**PUD NO. 1 OF SKAGIT COUNTY  
JUDY RAW WATER PUMP STATION REPLACEMENT PROJECT**

**ADDENDUM NO. 3**

Date of Issue: October 30, 2020

SHEET	E-2
DWG NO.	158
DATE	JAN. 1988
PROJ NO.	S21482.A1

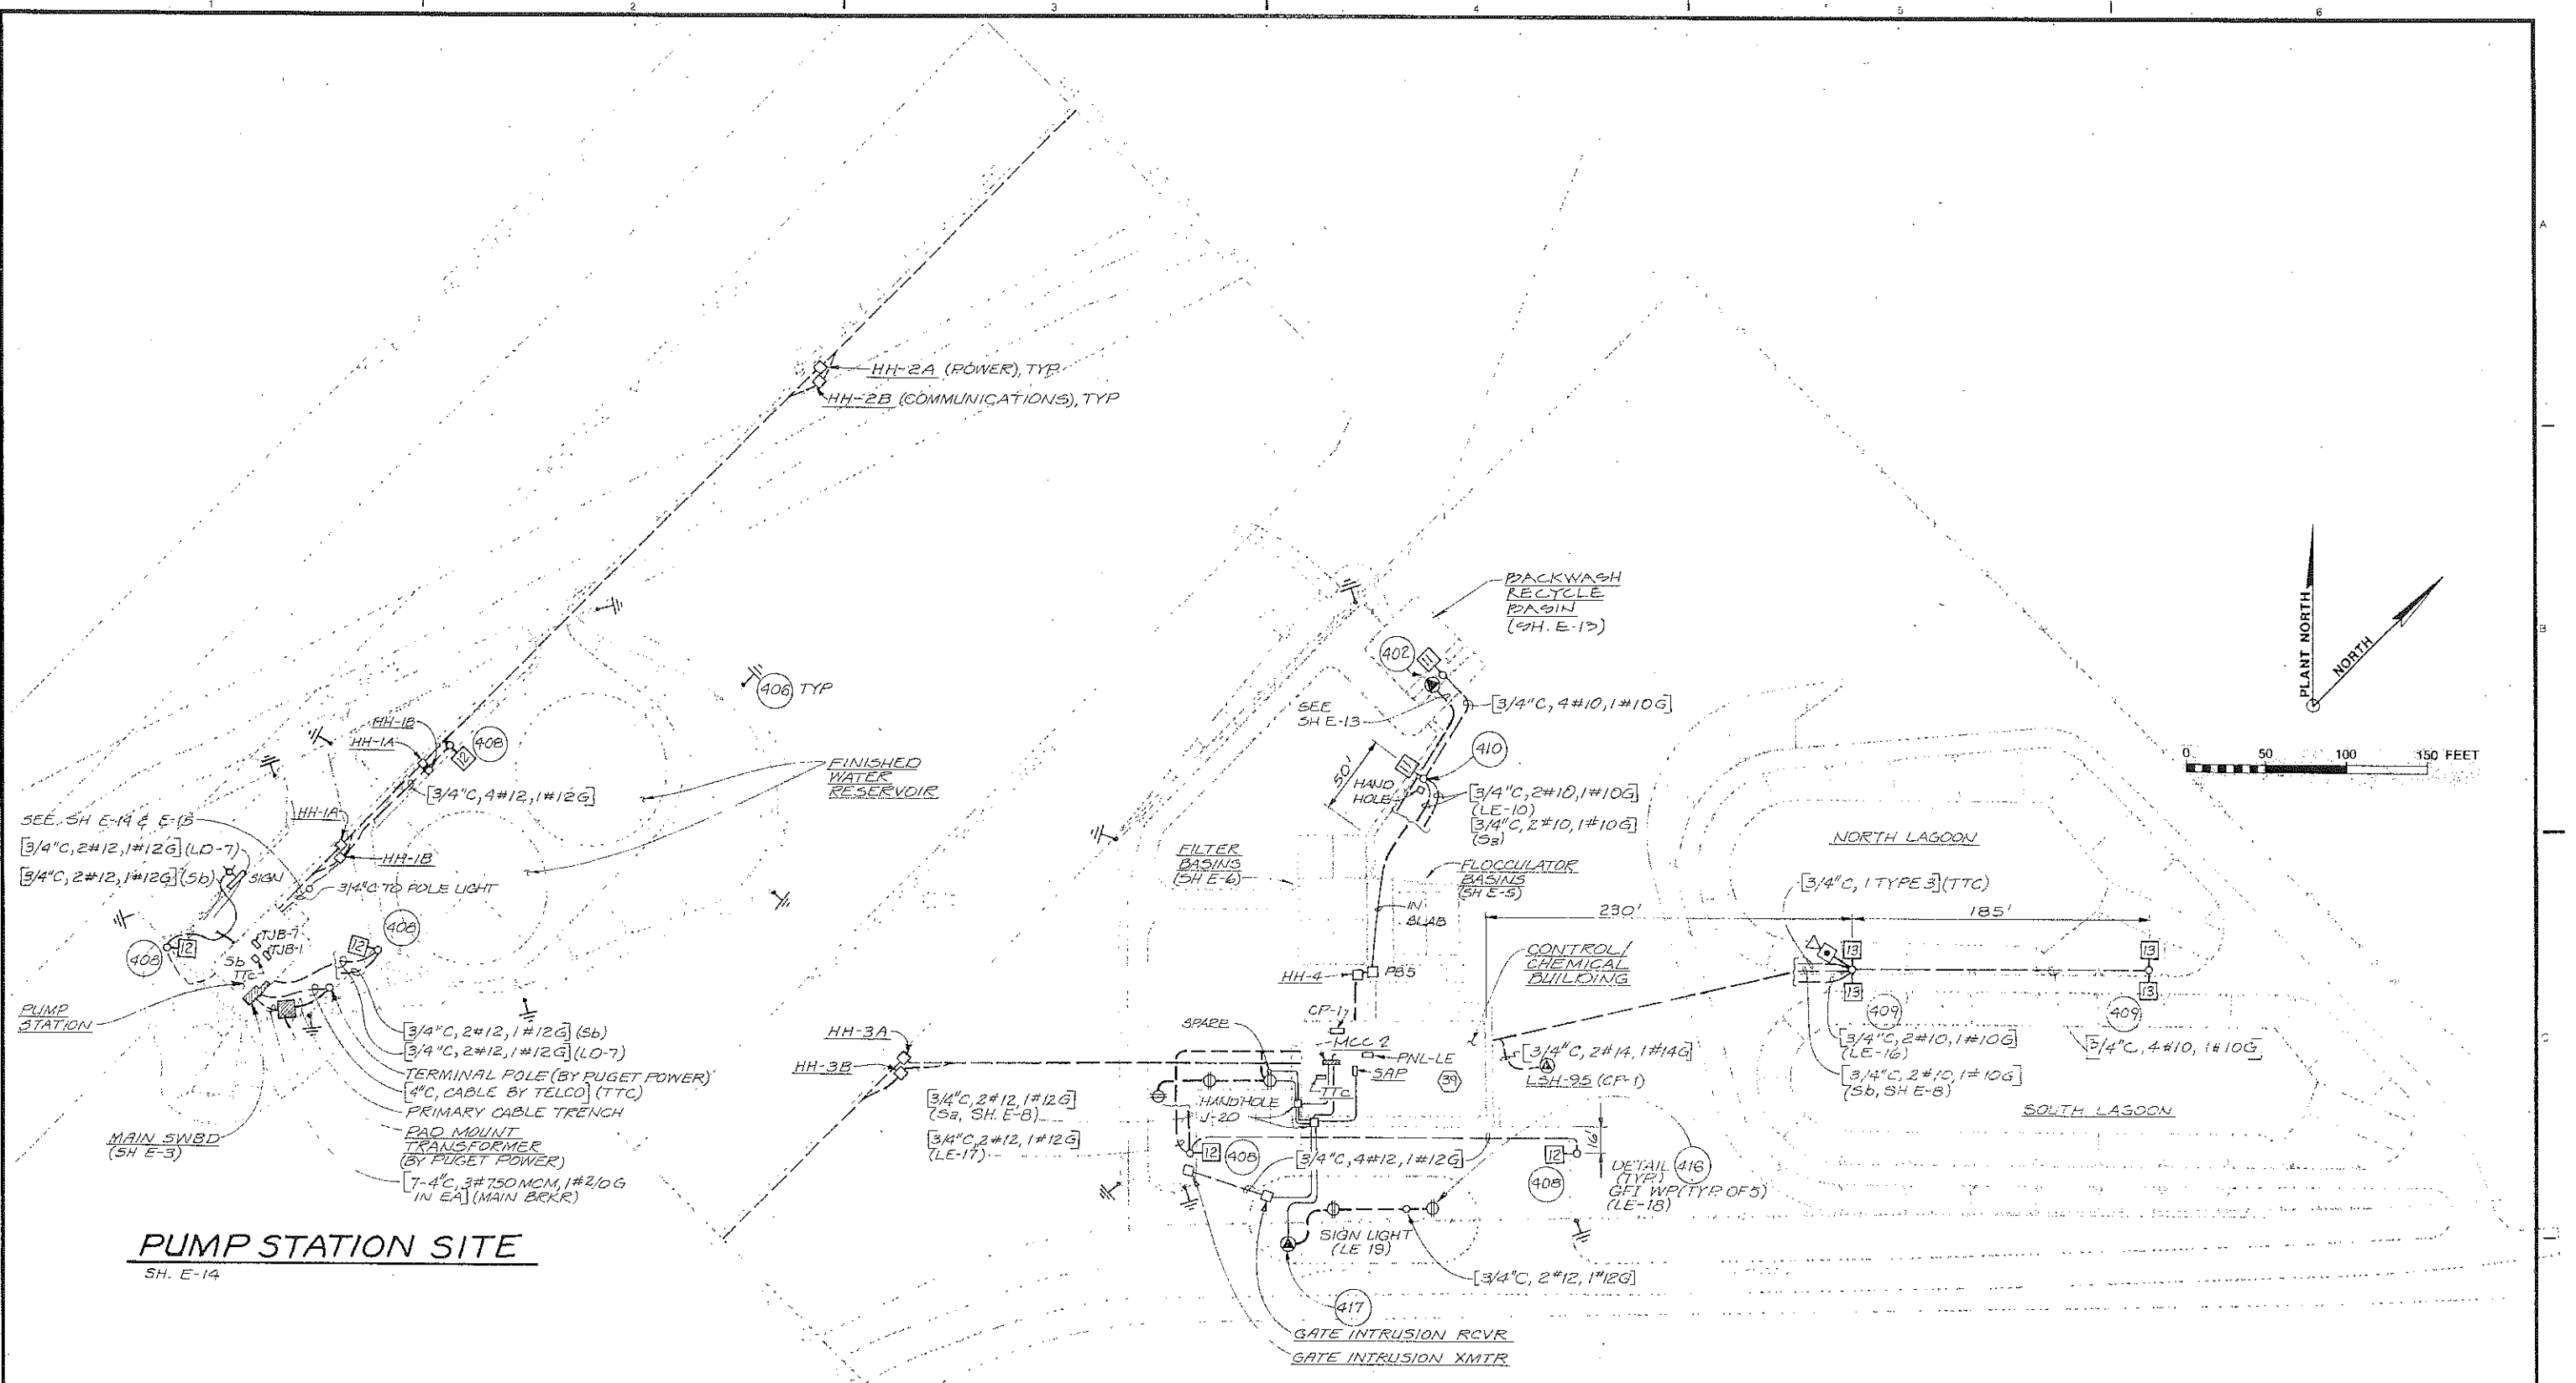
Record drawing E-2, "Electrical Site Plan", has been included to show the conductor length.

6. Routing conduit indicate the destination for P14 is MCC-2. Please provide the location of MCC-2.

**The location of MCC-2 is shown on record drawing E-2, "Electrical Site Plan", which has been included with this addendum.**

**MAIN SWITCHBOARD & MCC 1 ONE LINE DIAGRAMS & ELEVATIONS**

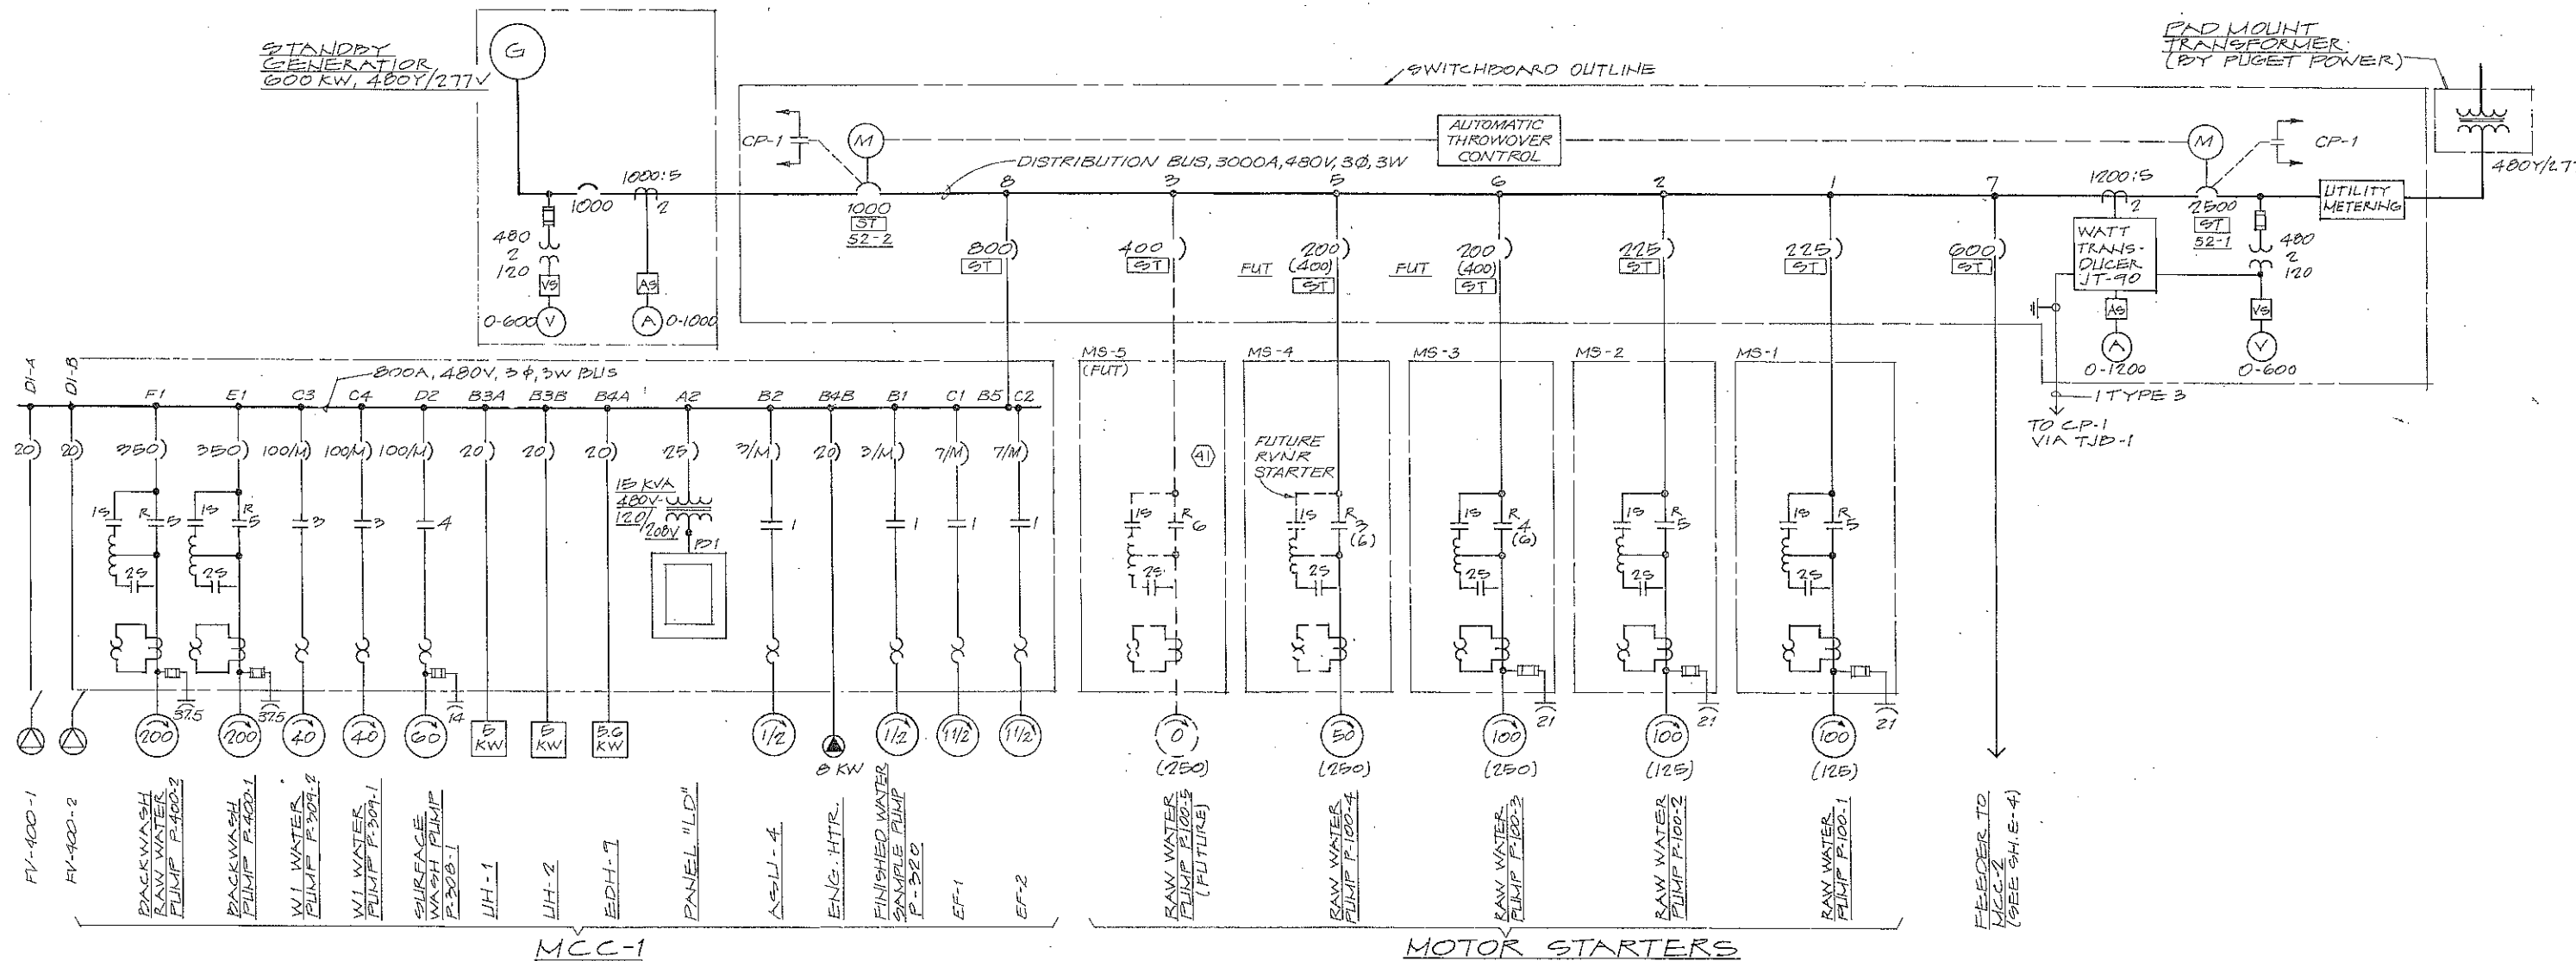
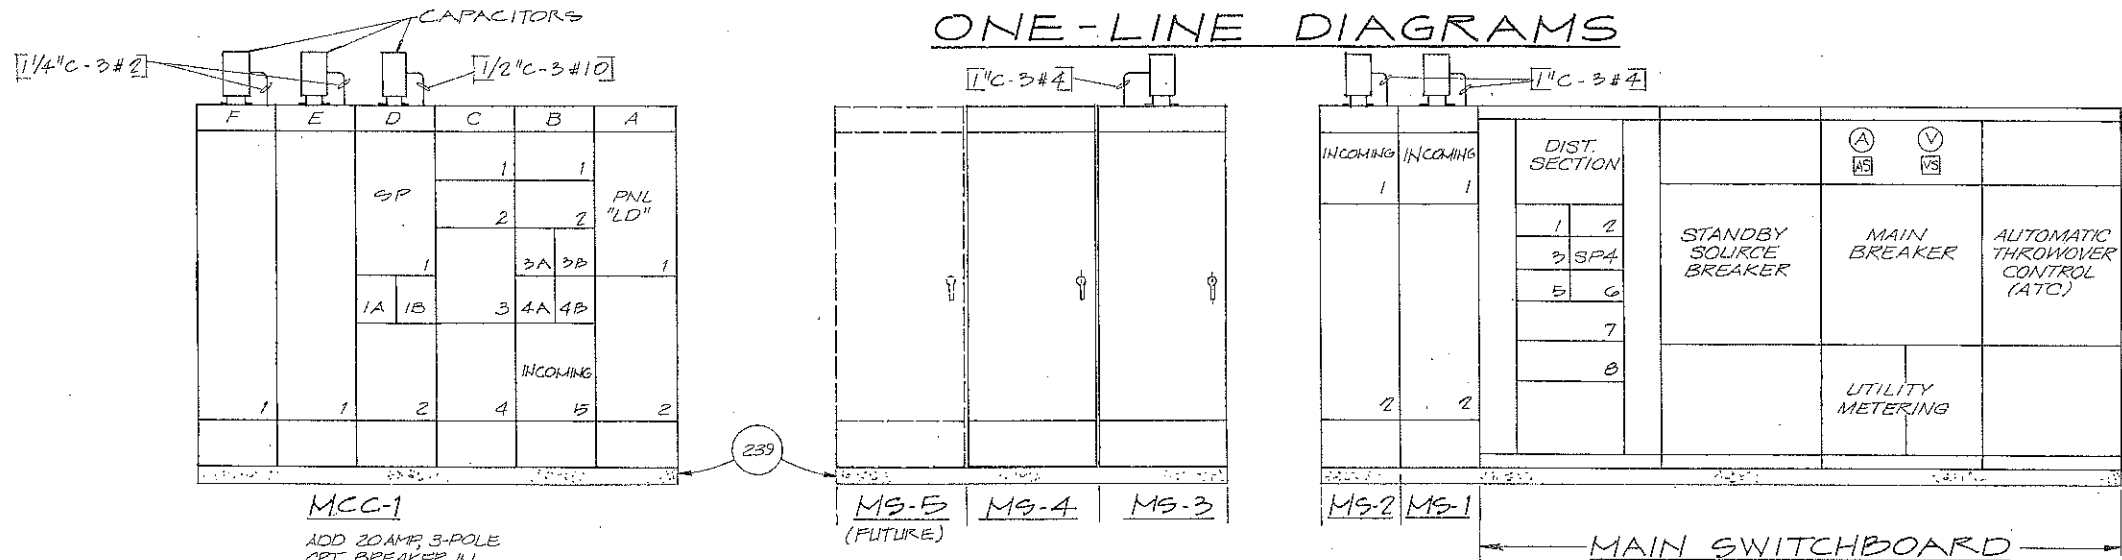
7. Can the owner provide the existing one-line diagram showing all the connections to the existing switchboard that's being removed?

**Record drawing E-3, "Main Switchboard & MCC 1 One Line Diagram & Elevations", has been included with this addendum.**

**PUMP STATION — POWER PLAN & LIGHTING PLAN**

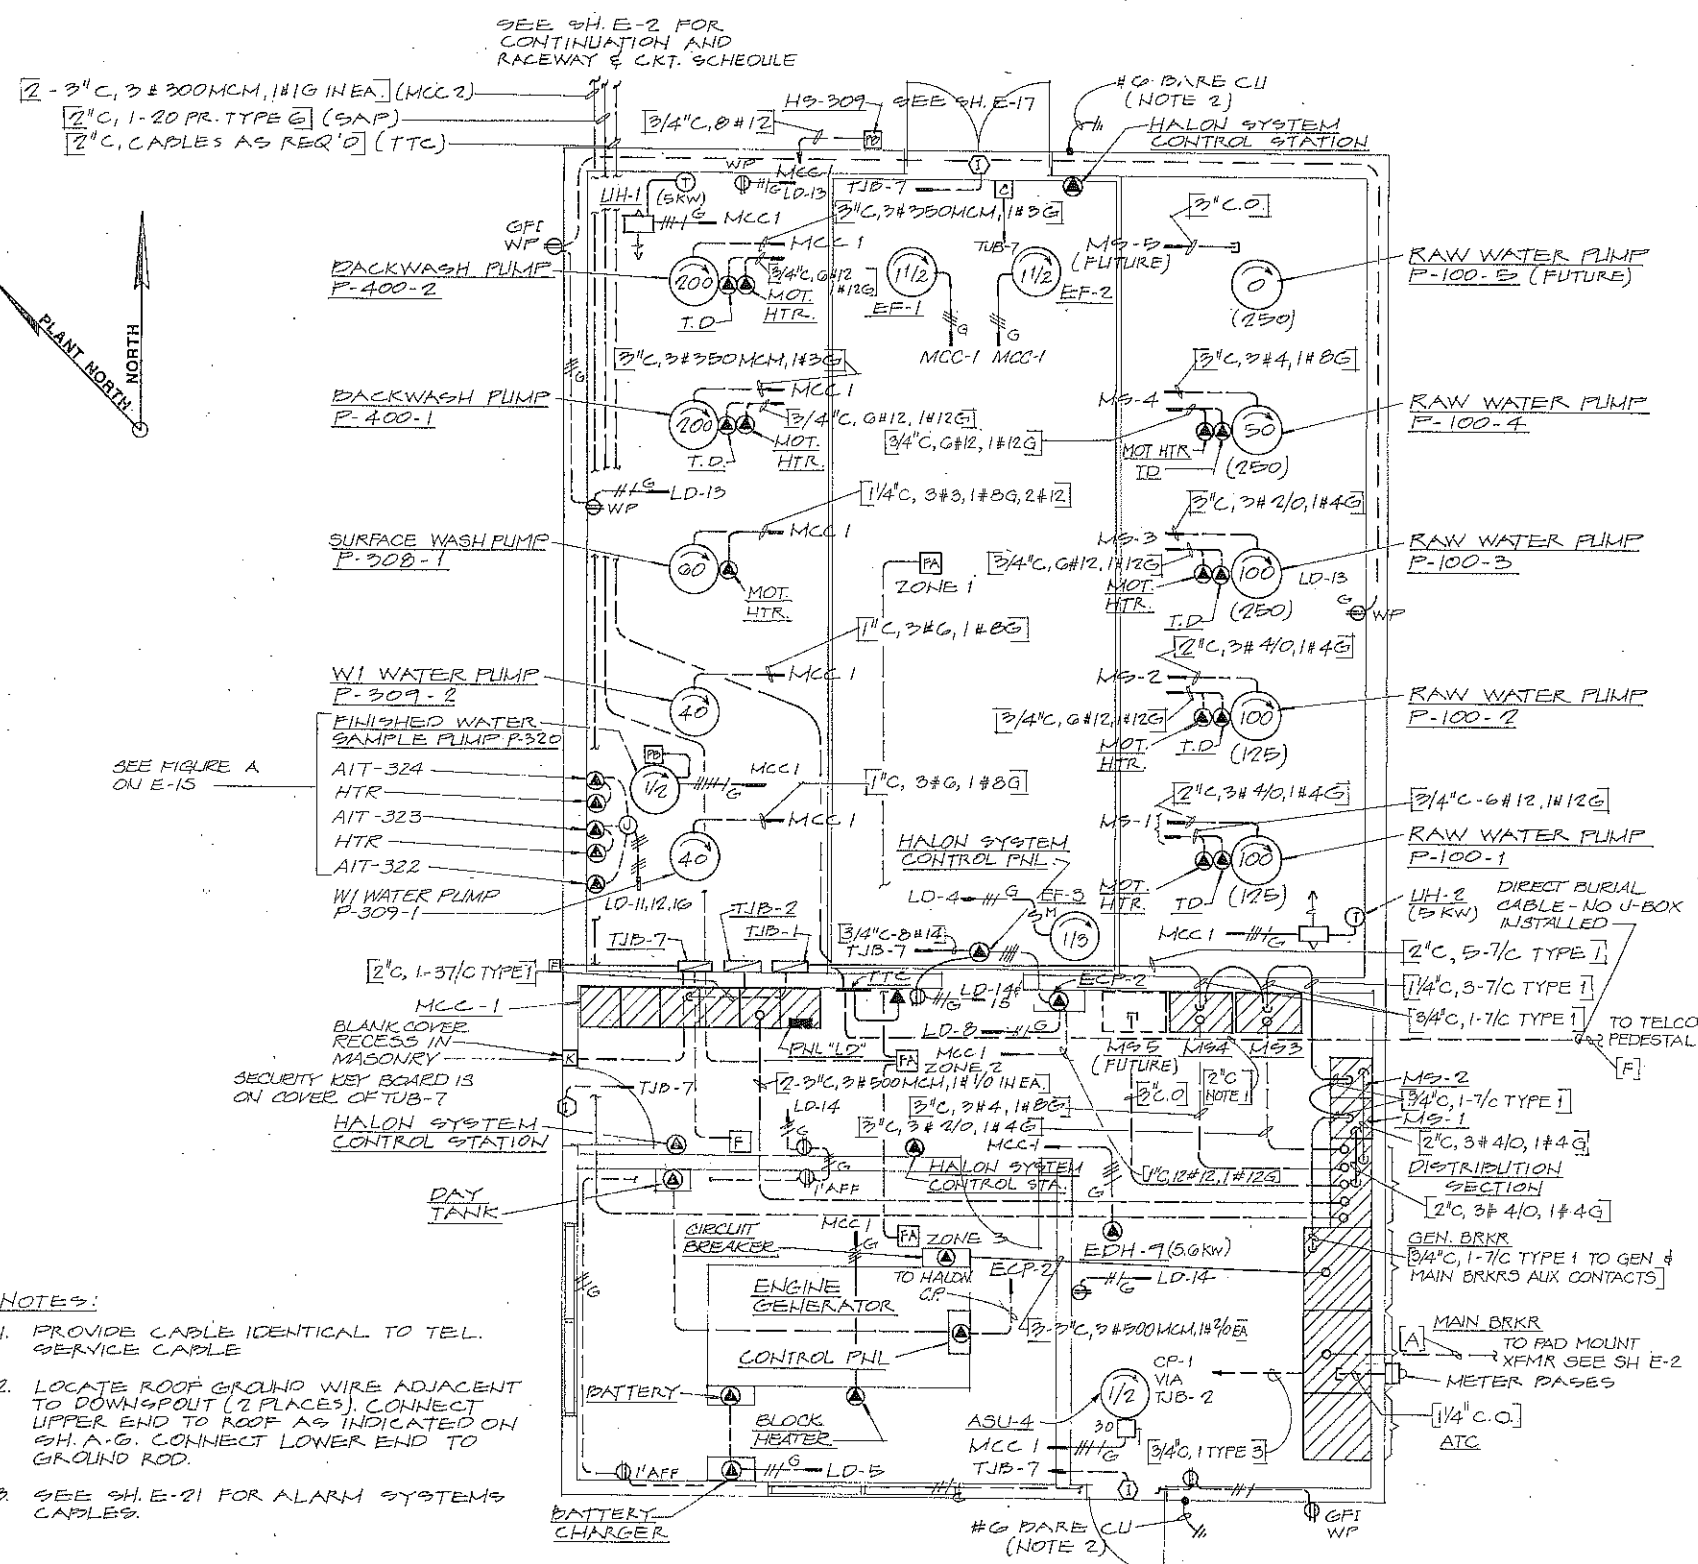
8. Please provide as-built drawings showing conduits routing from existing MS enclosures to existing raw-water pumps.

**Record drawing E-14, "Pump Station – Power Plan & Lighting Plan", has been included with this addendum.**
